Project
**East West Rail
(Western Section)
Phase 2**

Drawing Title
**PASSING PLACE A3_P_6
GENERAL ARRANGEMENT**

Stage 2 Road safety audit response report

Offline Highways Passing Places – Package 2 – Oxfordshire (A3 Marsh Gibbon – Compound Access)

CHAINAGE - 78.0000

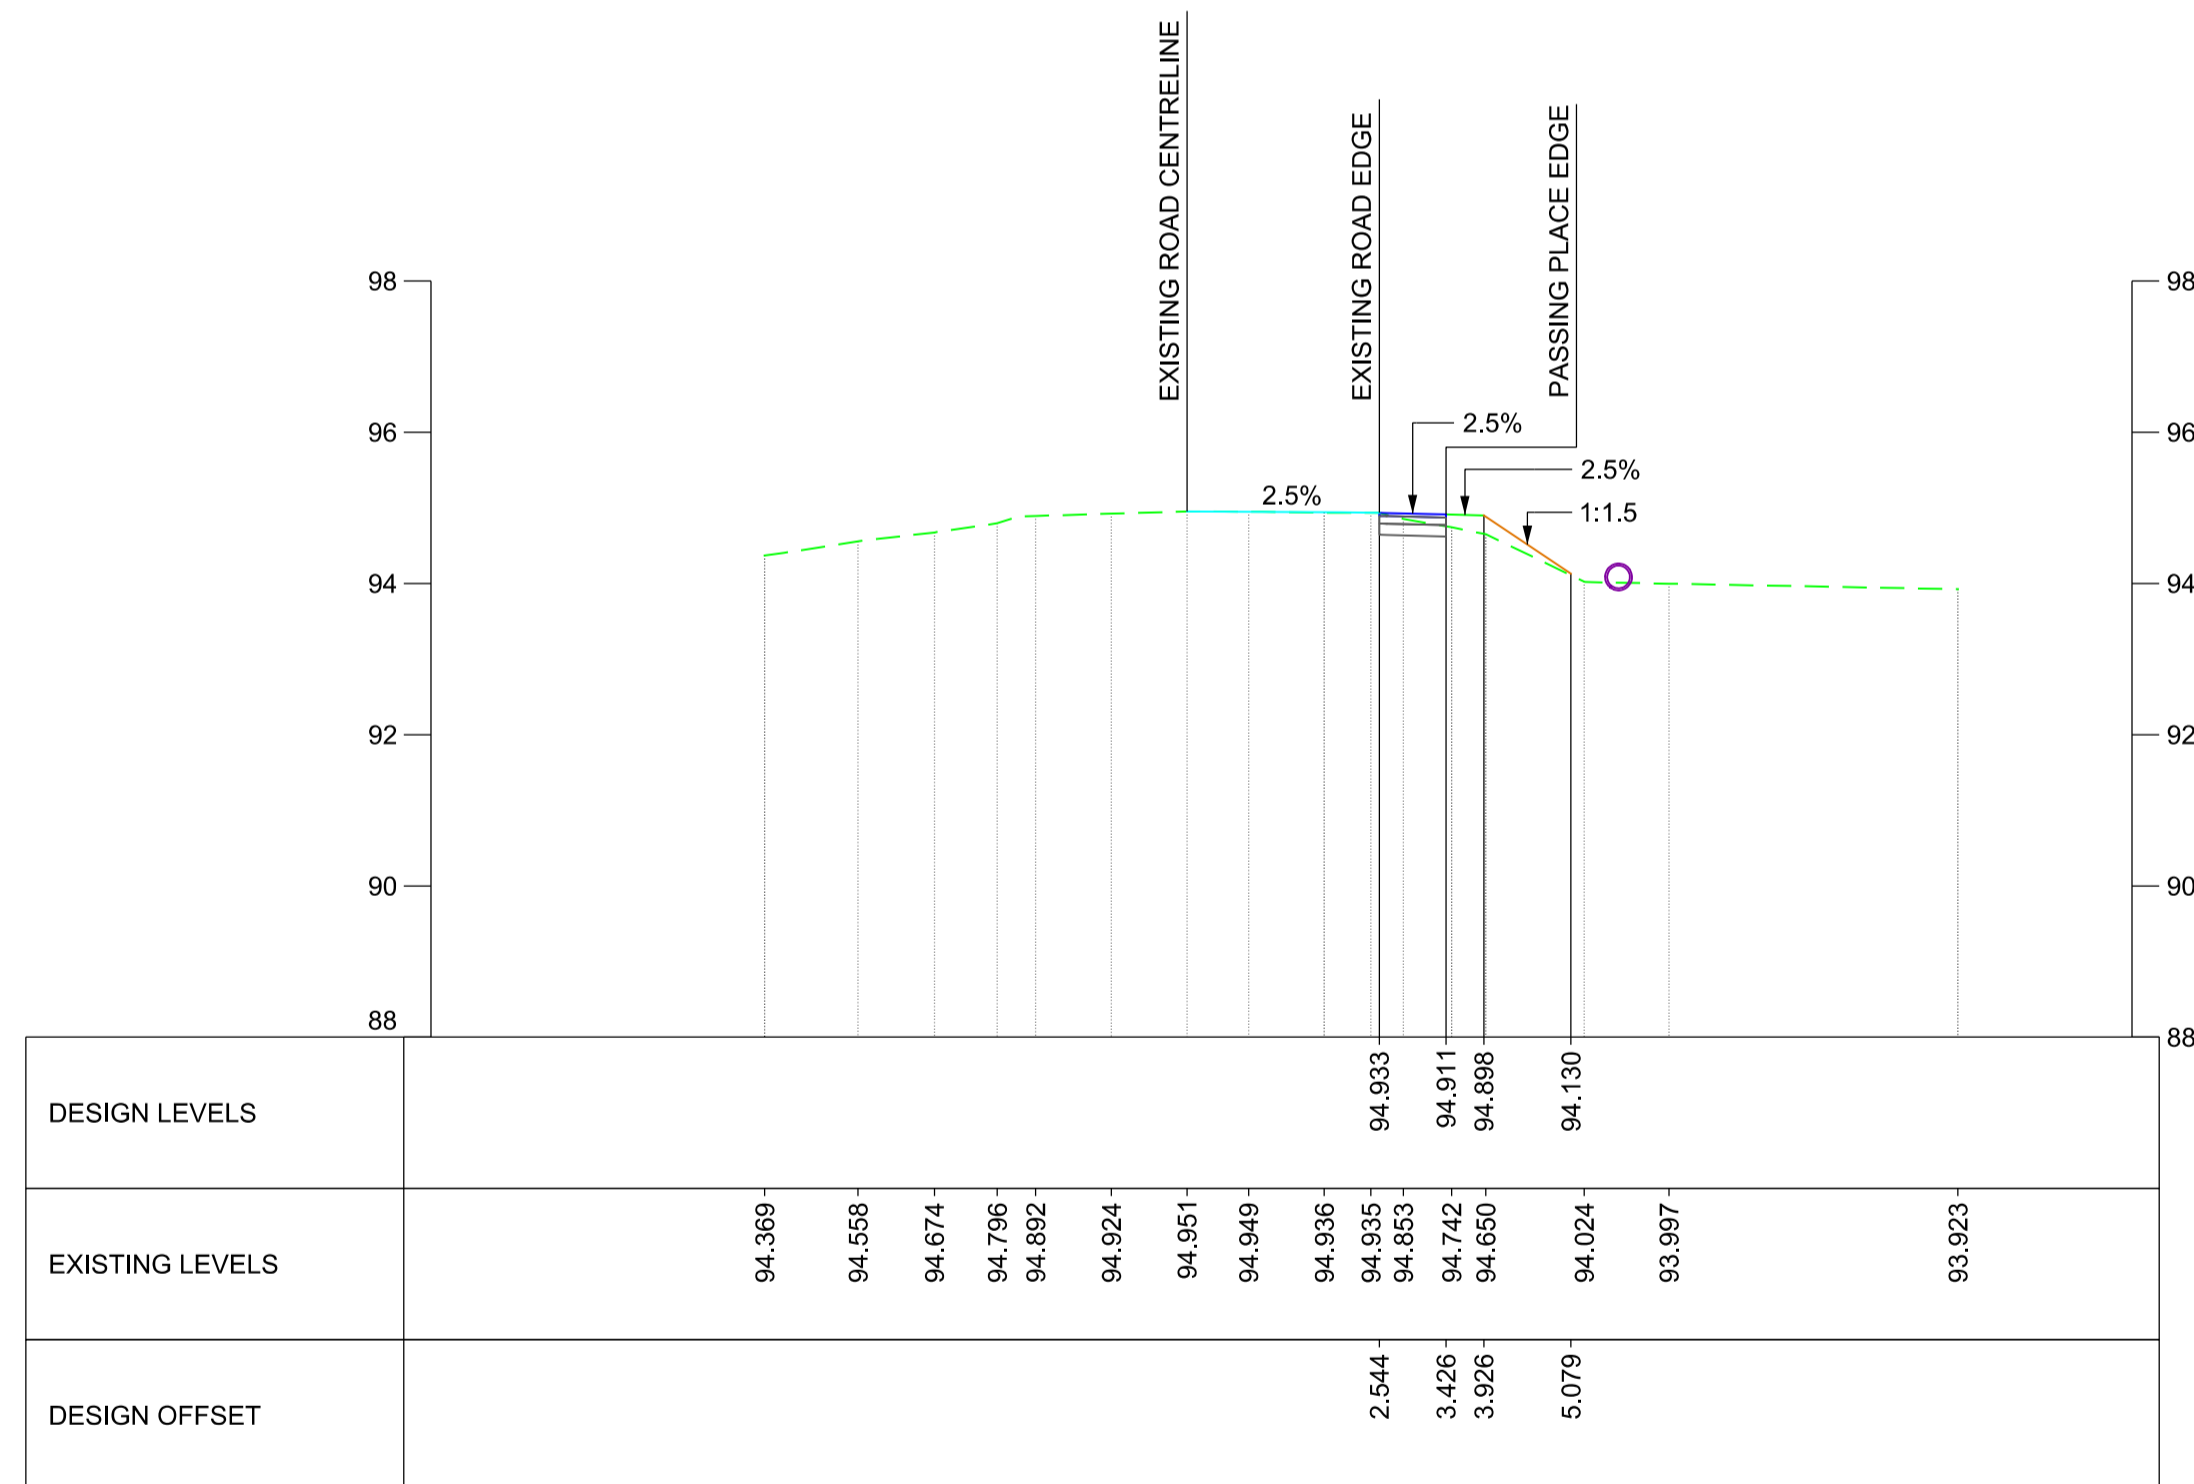
Location: Passing Places A2-P-2, A3-P-2, A3-P-3, A3-P-4, A3-P-5, A3-P-6, A3-P-7, A3-P-8, A3-P-9 and A3-P-10.

Passing places are proposed in positions where vegetation may restrict drivers' visibility of the route and the visibility of vehicles using the passing places. With this limitation, drivers of construction vehicles may not be aware that they should wait and might proceed, increasing the risk of side swipe collisions, or the risk of vehicles leaving the carriageway

on narrower sections of carriageway. Additionally, drivers of approaching vehicles may not anticipate the construction vehicle leaving the passing place, leading to side swipe or head on collisions.

The existing vegetation should be cut back to ensure clear visibility to all traffic signs and to keep the carriageway clear from obstructions.

2.5	<p>Passing Places A2-P-2, A3-P-2, A3-P-3, A3-P-4, A3-P-5, A3-P-6, A3-P-7, A3-P-8, A3-P-9 and A3-P-10. Unnamed Road (towards Mill Road) and Unnamed Road.</p>	<p>Driver visibility reduced by vegetation Passing places are proposed in positions where vegetation may restrict drivers' visibility of the route and the visibility of vehicles using the passing places. With this limitation, drivers of construction vehicles may not be aware that they should wait and might proceed, increasing the risk of side swipe collisions, or the risk of vehicles leaving the carriageway on narrower sections of carriageway. Additionally, drivers of approaching vehicles may not anticipate the construction vehicle leaving the passing place, leading to side swipe or head on collisions. There is further risk that existing vegetation will encroach into the carriageway increasing the risk of damage to vehicles and HGVs being pushed towards oncoming traffic.</p>	<p>The existing vegetation should be cut back to ensure clear visibility to all traffic signs and to keep the carriageway clear from obstructions.</p>	<p>Accept the RSA problem and recommendation made by the RSA team. The site clearance drawings include vegetation clearance to achieve required visibility and signage strategy drawings likewise include this provision.</p>	Accepted	Proceed as Design Team Response
